Uroskop D1/D2/D3 (PL SU)

Update Instructions SP008/03/S

Title: Corrective Action

Fig. 1

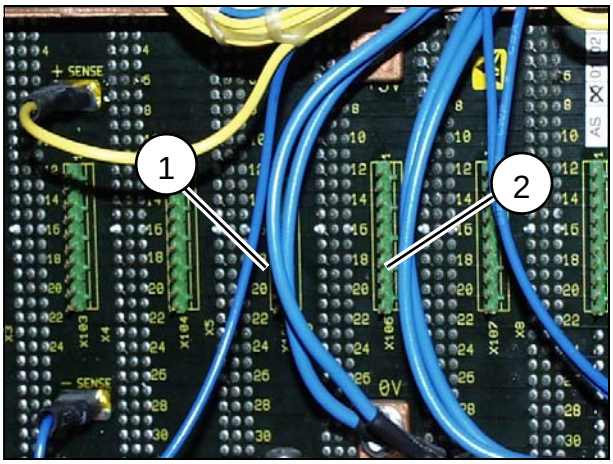
The collimator and operation controller boards (D3) on the UROSKOP D systems with POLYDOROS SU generators are fit differently as on those UROSKOP D systems having POLYDOROS SX/LX generators. Therefore two jumpers must be replugged.

- Swivel out the control unit M20.
- Remove any EMC covers
- Disconnect the cables from the connecting strips X103.7 to X108.7 and from X103.8 to X 108.8.
- Connect cable 1 to connecting strip X105.7 (1/Fig. 1) and to connecting strip X106.7 (2/Fig. 1).
- Connect cable 2 to connecting strip X105.8 (1/Fig. 1) and to connecting strip X106.8 (2/Fig. 1).
- Reattach the EMC covers, swivel in the control unit and fasten it with screws.
